**ADDENDUM #2**  
**Miracle Fields at Harrison Community Center**  
**11-0302**

**1. SAS clarifications to plans and specifications. These sheets are to supersede the previous information and are to be used in the bidding process.**

**ADDENDUM #2**

HARRISON RECREATION CENTER  
MIRACLE FIELD IMPROVEMENTS

**2**  
EXHIBIT

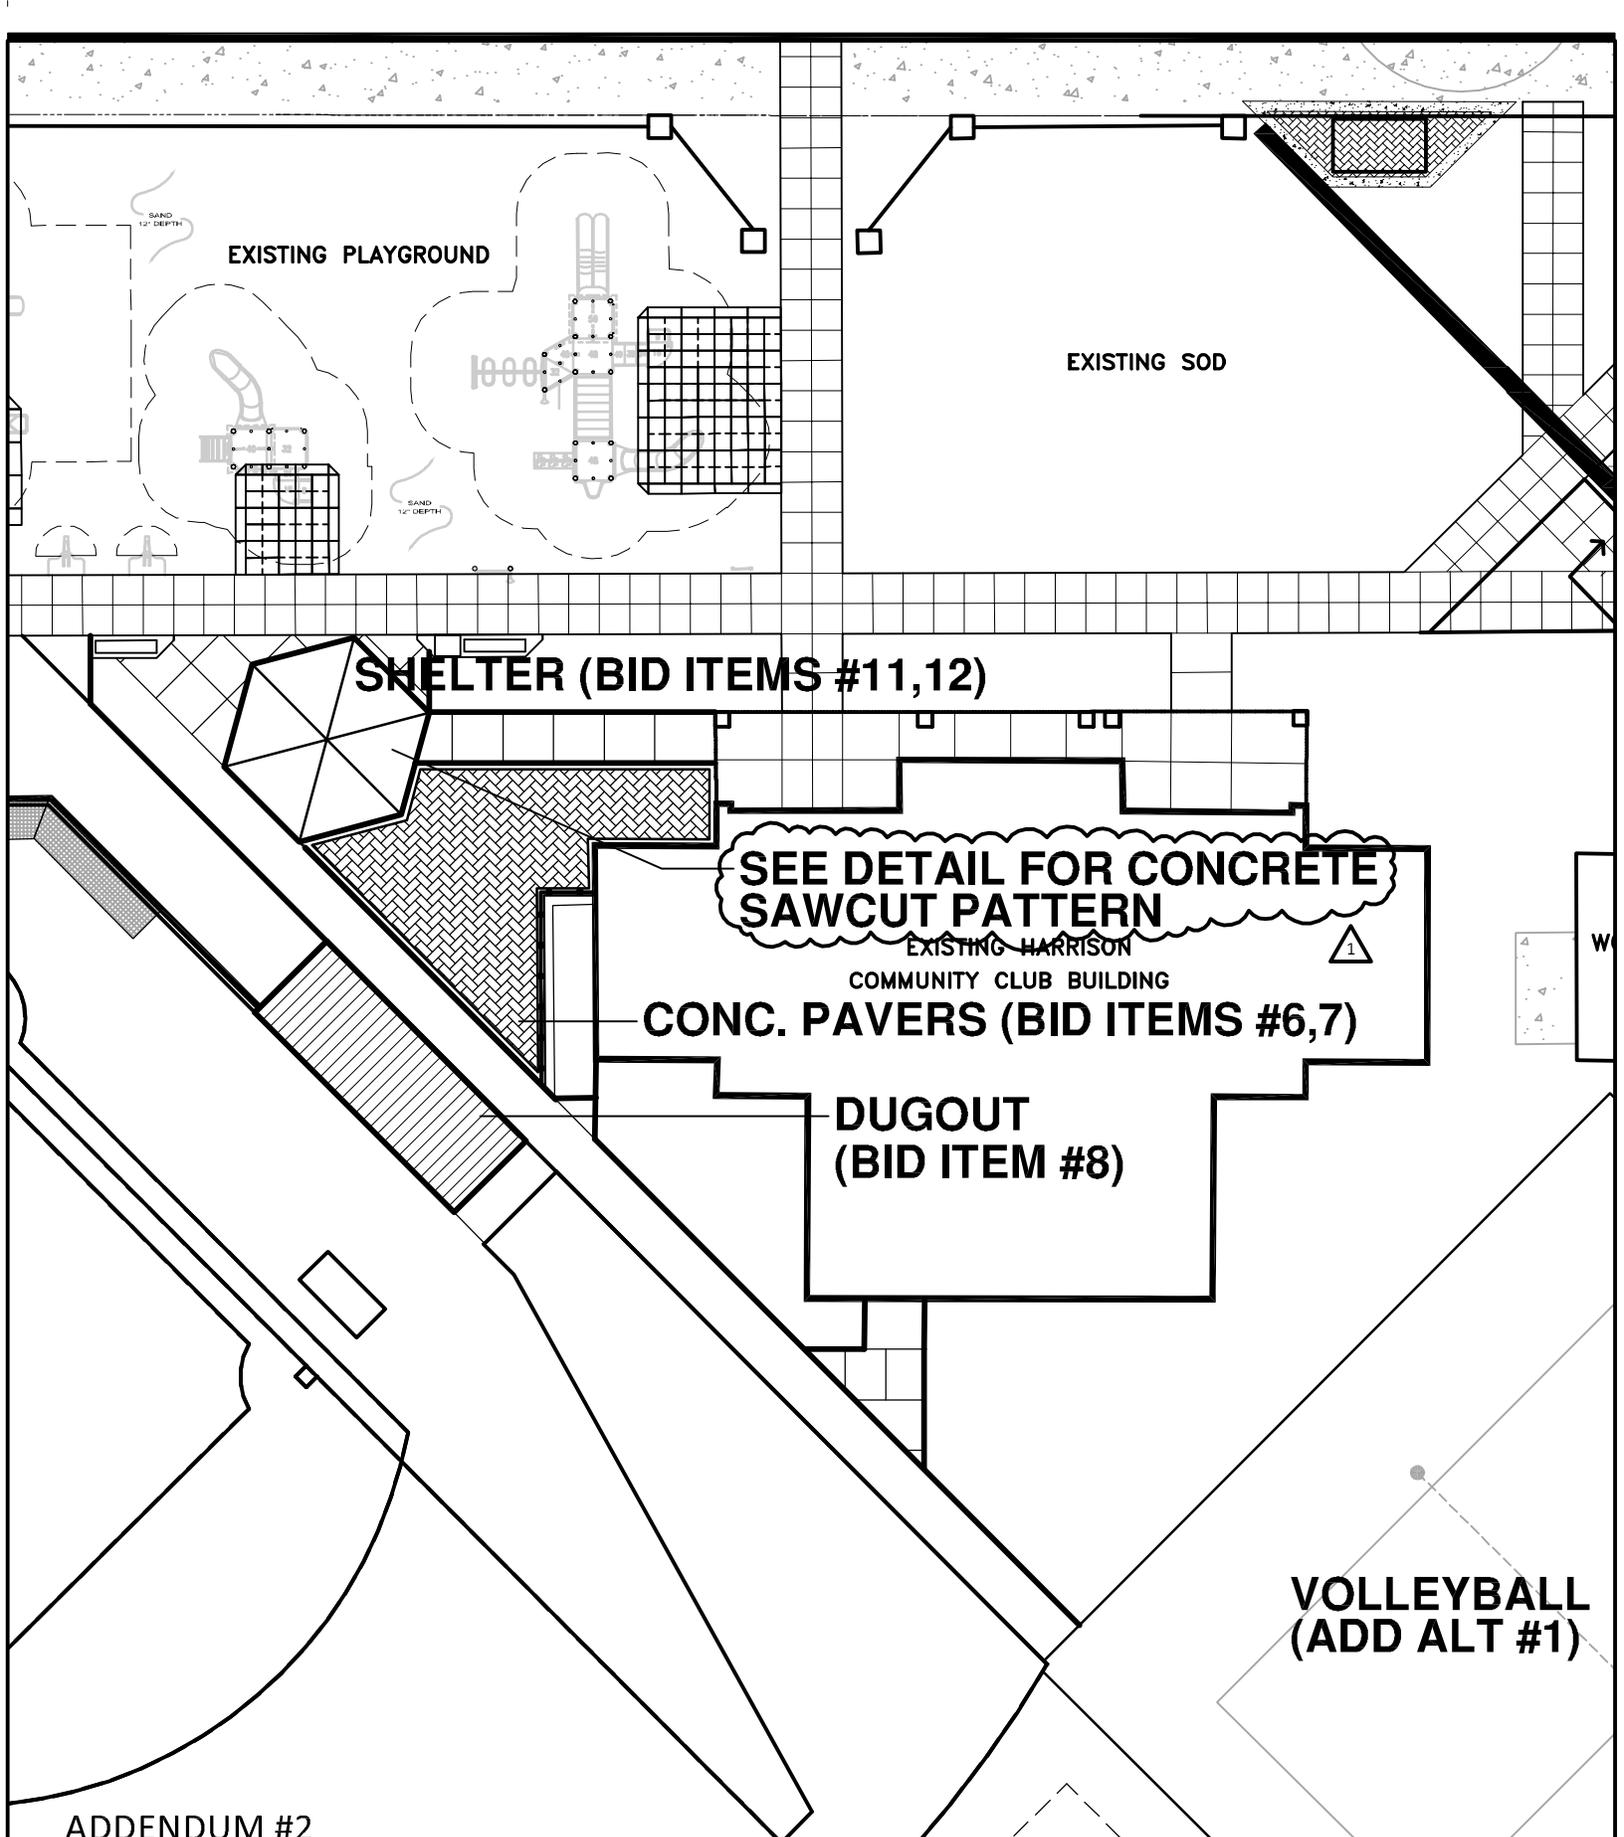
**SHELTER (BID ITEMS #11,12)**

**SEE DETAIL FOR CONCRETE SAWCUT PATTERN**

SAWCUT JOINTS  
UNDER SHELTER  
(TYPICAL)

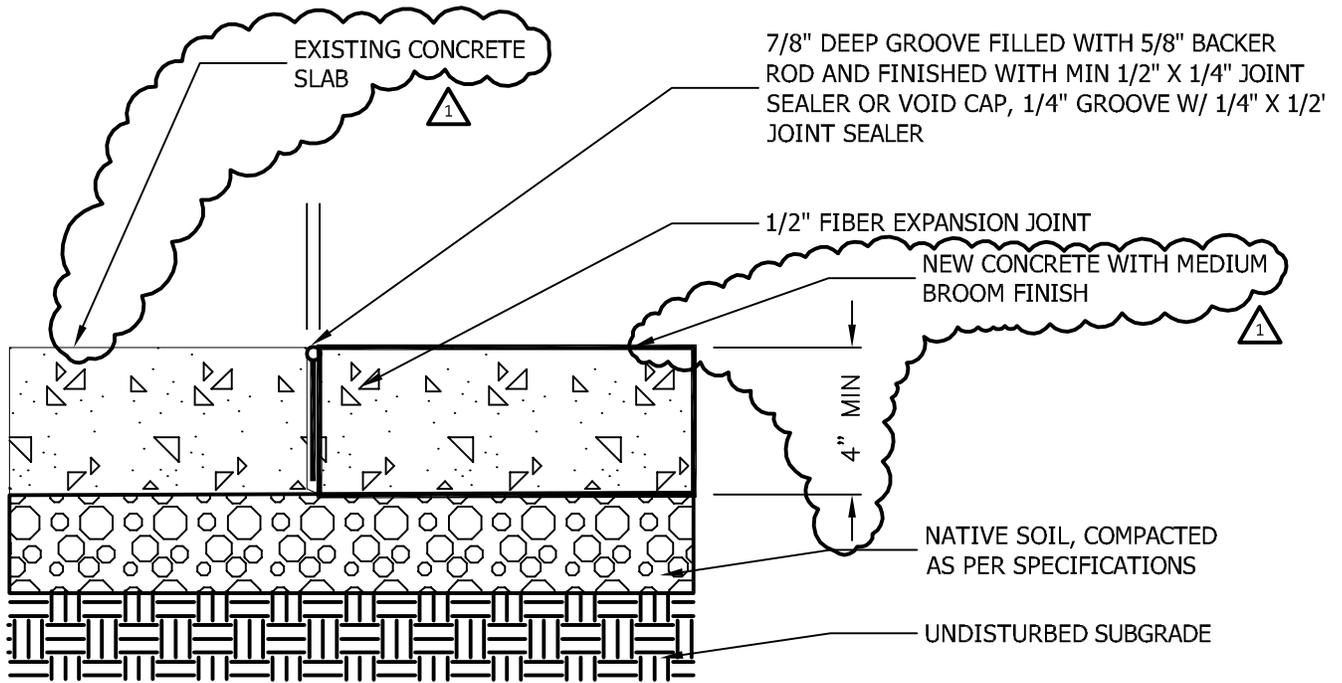
SAND  
12" DEPTH

**2** CONTROL JOINT DETAIL TYP.  
NTS

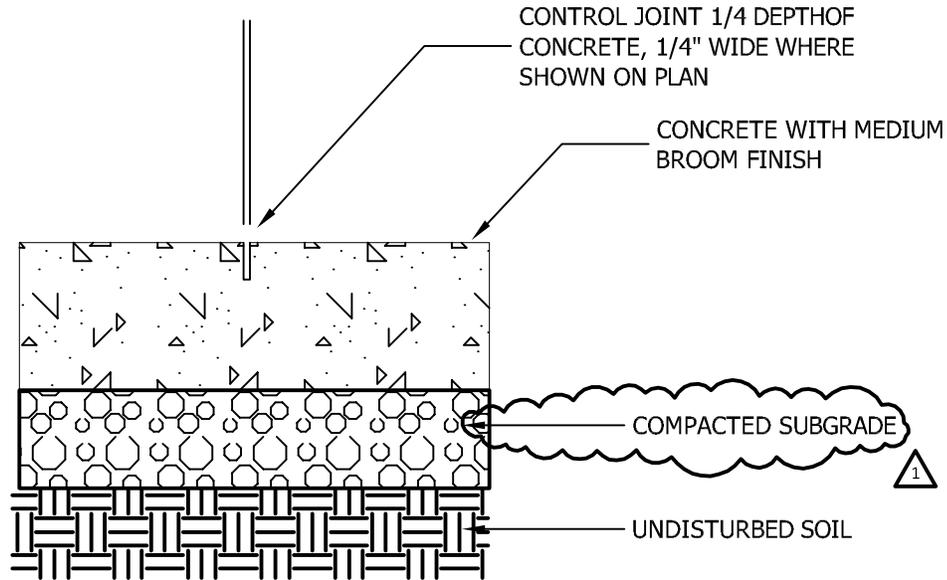
**1** EXPANSION JOINT DETAIL TYP.  
NTS

**3** BALLFIELD SECTION  
BID ITEMS #4  
NTS

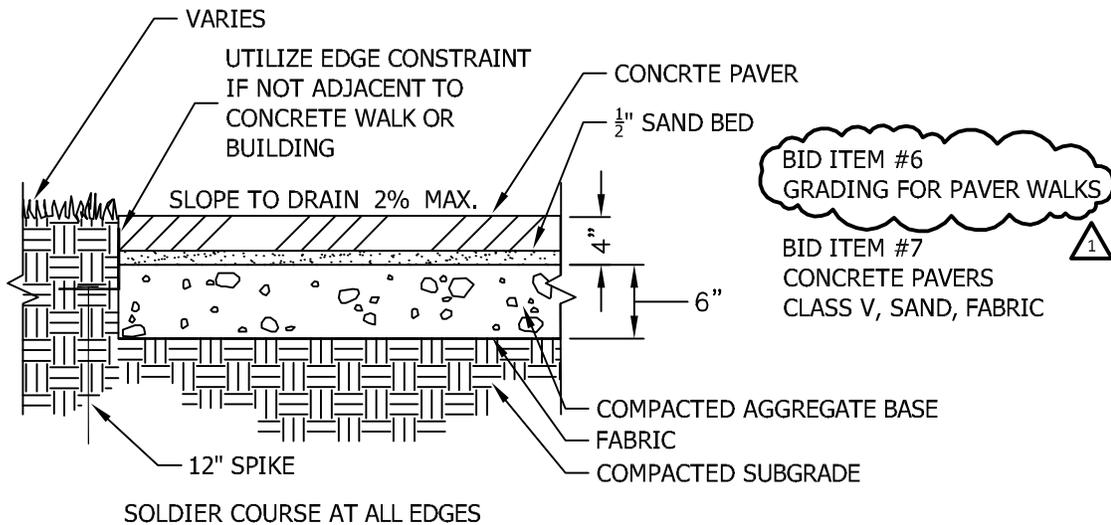
1/2" "EVERTOP" SURFACE (BID ITEM #4) AS PROVIDED BY SURFACE AMERICA OR "DREAMFIELD" BY BEYNON SPORTS SURFACE COMPANY

PROVIDE ASPHALT MIXES FOR APPROVAL

**2** DUGOUT LAYOUT  
 NTS

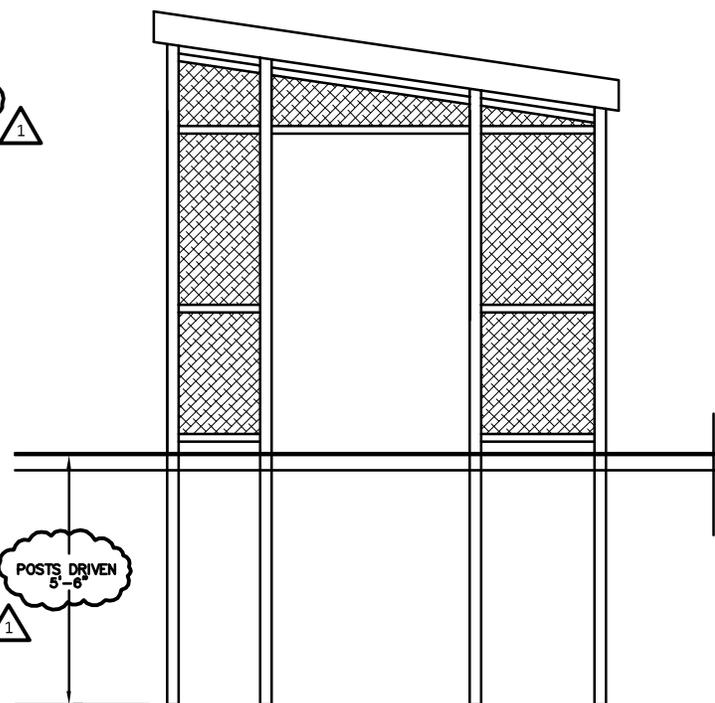
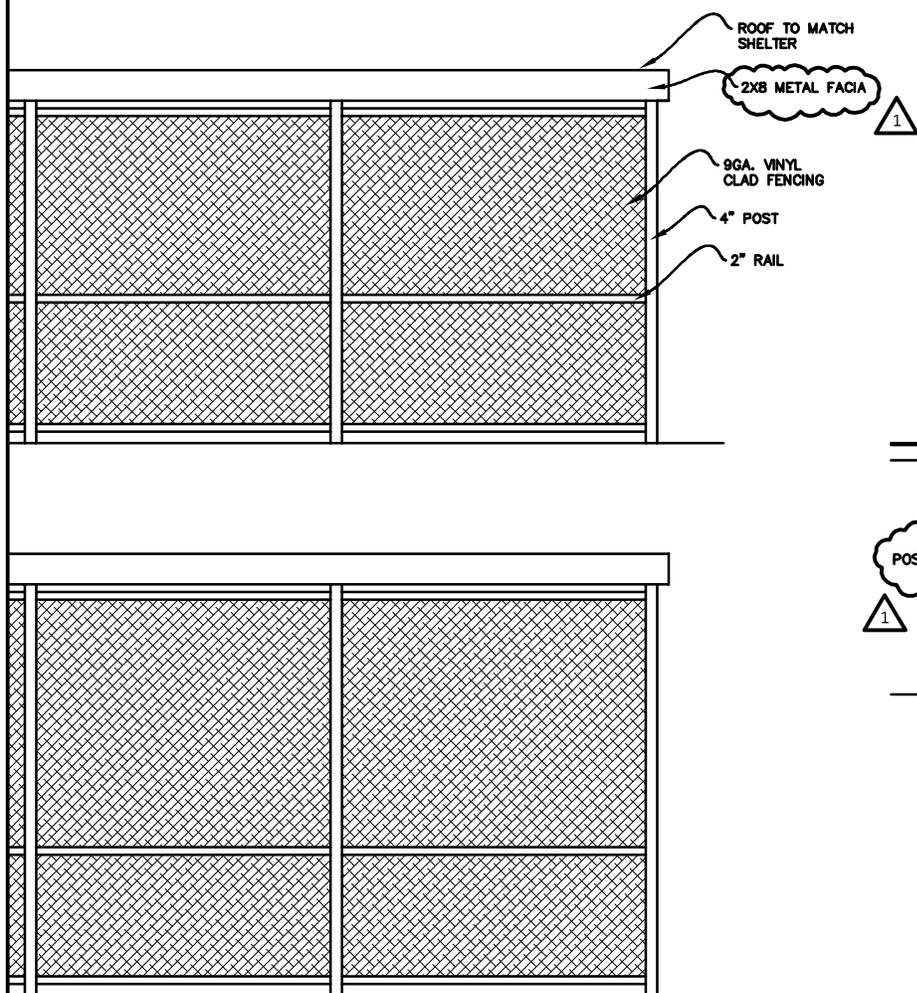
DUGOUT TO BE OPEN ON BOTH ENDS  
 PROVIDE SHOP DRAWINGS FOR APPROVAL WITH  
 STRUCTURAL ENGINEER REVIEW AND SIGNATURE  
 COLOR COLONIAL RED MULTI RIB METAL ROOF  
 TO MATCH PARK SHELTER AS PROVIDED BY  
 PINNACLE WOOD SHELTERS  
 PROVIDE 1/2\"/>
